Daimler Surveillance Panel Meeting Minutes

June 24, 2019

Daimler SP Face-to-Face Meeting
June 24th, 2019

FIG. A4.15 Location of Exhaust Tailpipe Sensors

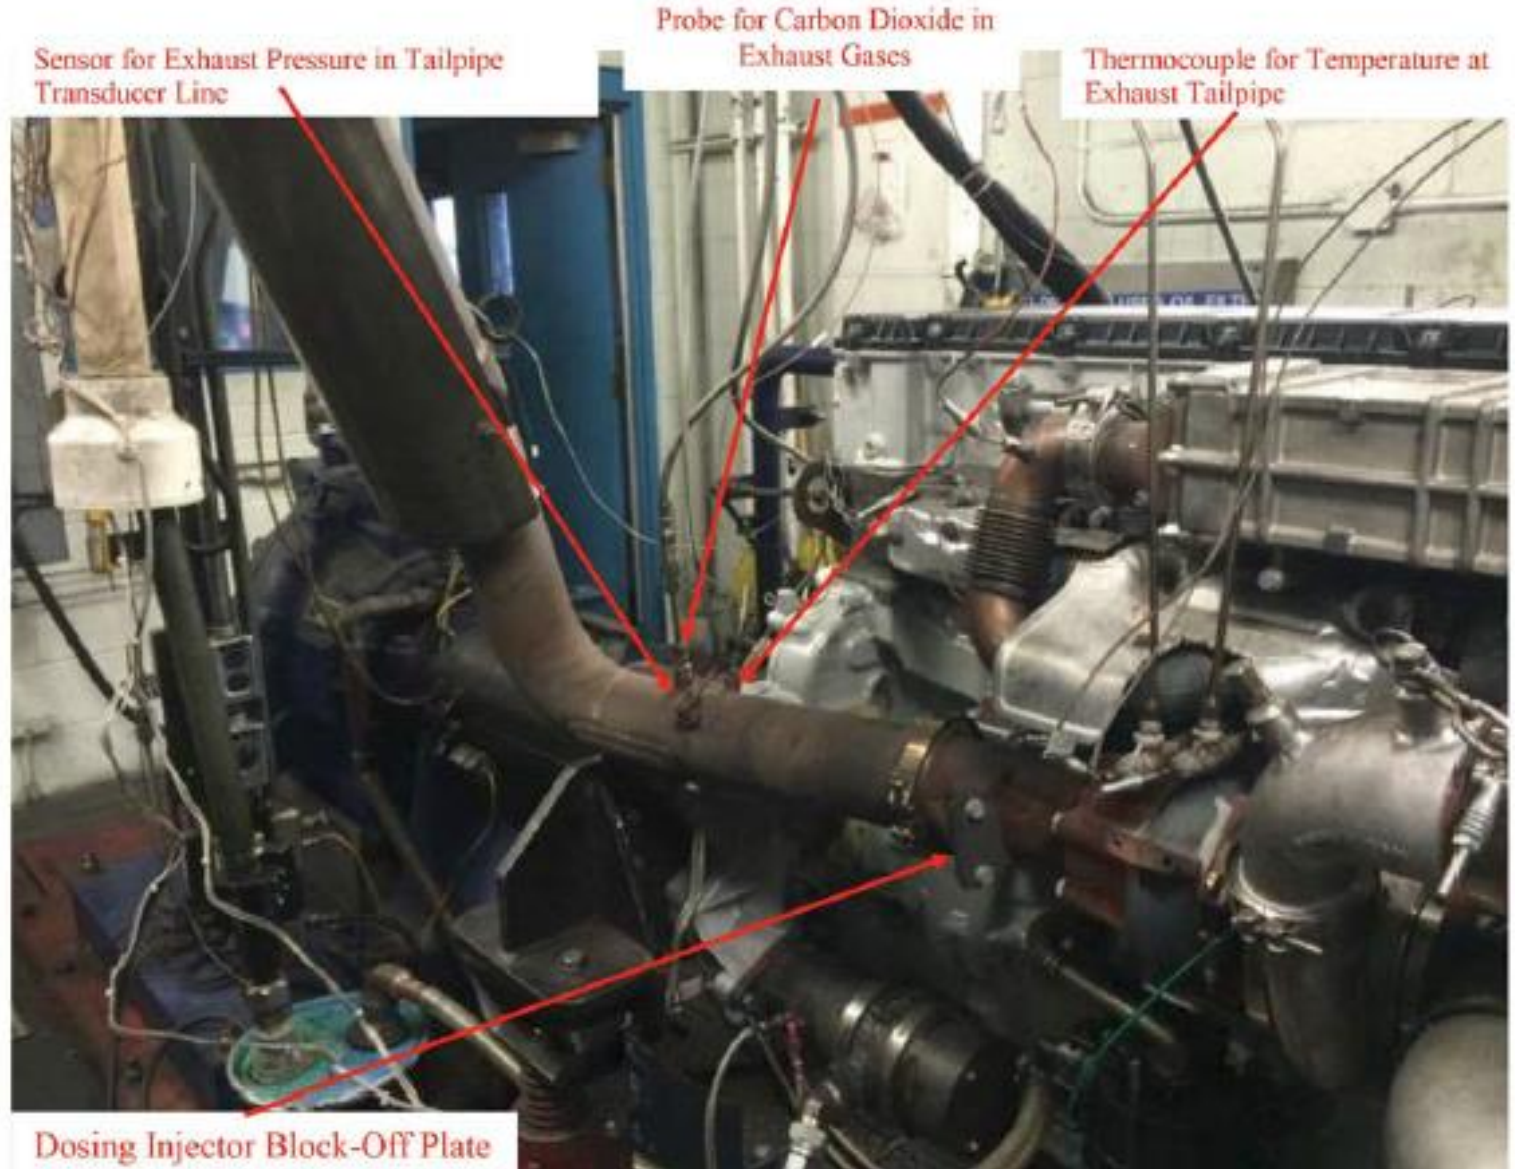
Sean brought up that the wording in section 8.6.3.4 of the exhaust pressure in tailpipe and CO2 placement did not align with the corresponding Figure A.15. It was stated that it is difficult to see in the figure, however the position of these items do meet the wording requirements. **Action Item:** Patrick will be updating the image in this figure so that it is can increase the accuracy in how this is depicted and avoid confusion.

The DD13 Scuffing test procedure currently calls out the tailpipe temperature location in section 8.6.2.12 which is a report only parameter and the controlled item which is exhaust pressure in tailpipe did not have a location specified. It was proposed that exhaust pressure tailpipe section 8.6.3.4 have a location specified as 270 +/- 50 mm as shown in the attached document and remove the temperature location specification since it is a non-critical parameter. This change will not impact where any of the labs had their current exhaust pressure tap located.

8.6.2.12 *Exhaust Temperature in Tailpipe* – Locate the thermocouple in the exhaust pipe downstream of the Exhaust Pressure in Tailpipe measurement location and upstream of the CO₂ probe. Refer to Fig A4.15.

8.6.3.4 *Exhaust Pressure in Tailpipe (Exhaust Back Pressure)* – Locate the pressure tap in a straight section of the exhaust pipe 270 +/- 50 mm downstream of the turbocharger outlet. Locate the pressure tap upstream of the Exhaust Temperature in Tailpipe thermocouple and CO₂ probe as shown in Figure A.15.

Daimler Rocker Arms Re-use Guidelines as presented to the Daimler Surveillance Panel

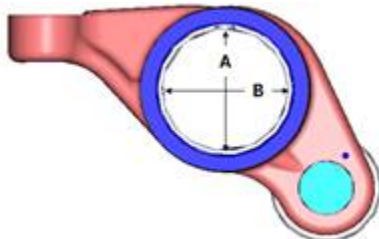
Measure the parts as shown below.

“B” is the original DIA (or close to it)

“A” is the wear dimension

A1 and A2 both need to be below the wear limit.

<36.050	Green	Ok to reuse
<36.100	Yellow	Can be reused, but keep an eye on it
>36.100	Red	Scrap

<26.050	Green	Ok to reuse
<26.100	Yellow	Can be reused, but keep an eye on it
>26.100	Red	Scrap

Cylinder Liners

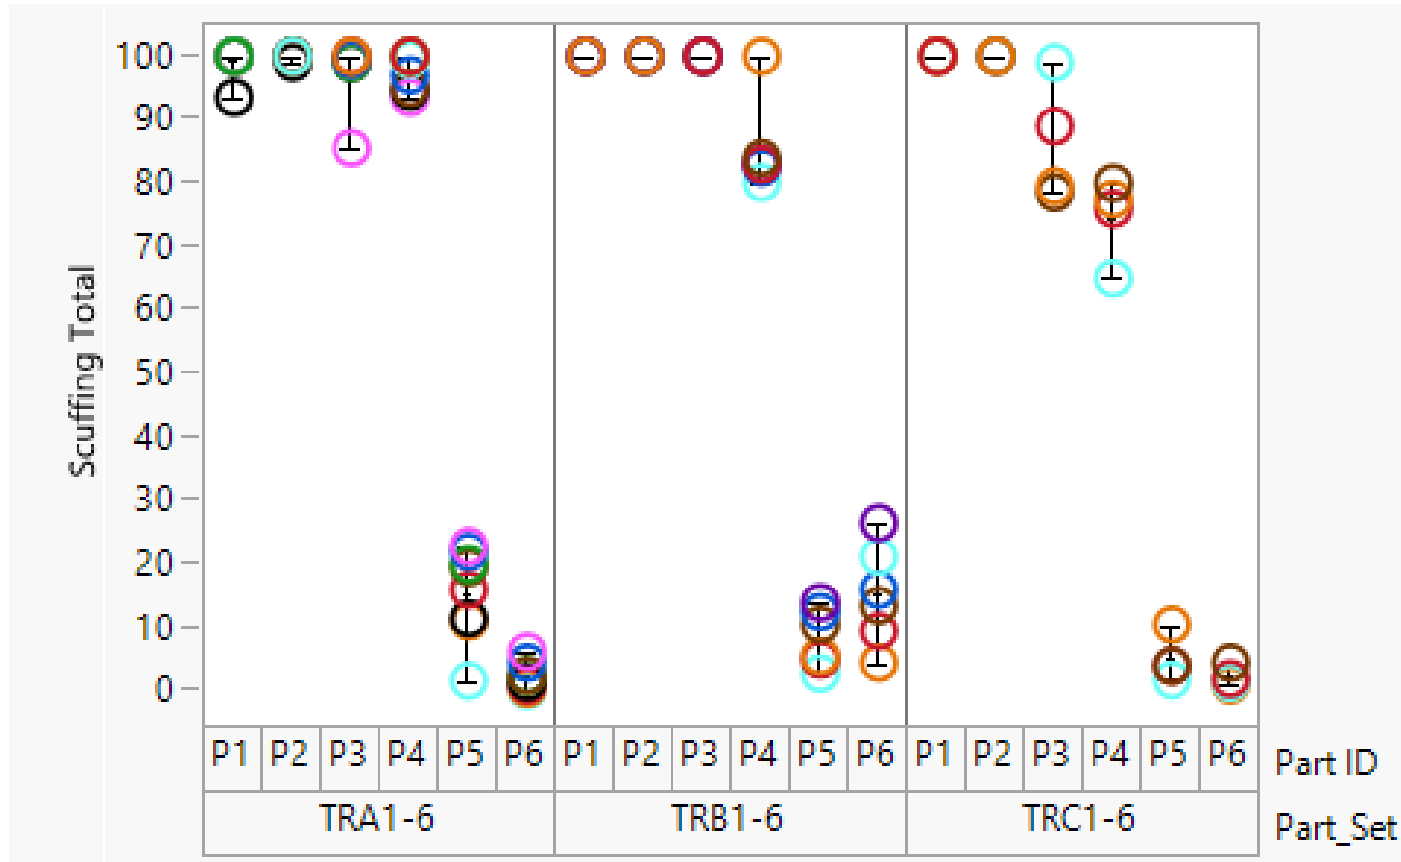
Review of the data from the Daimler SP Rater workshop from 2017 shows that there may be improvements that could be made to increase the accuracy of the ratings and perhaps remove un-necessary items from being rated. Please see attached “2017 Daimler SP Rater Workshop” presentation by Lubrizol. At the moment there is no criteria as to who can rate DD13 Scuffing test hardware. The data from the workshop shows that there is decent variation between a small number raters which are both high and not high volume raters. This data outlines that perhaps more training is required for raters or that there should be specifications on who is allowed to rate these components.
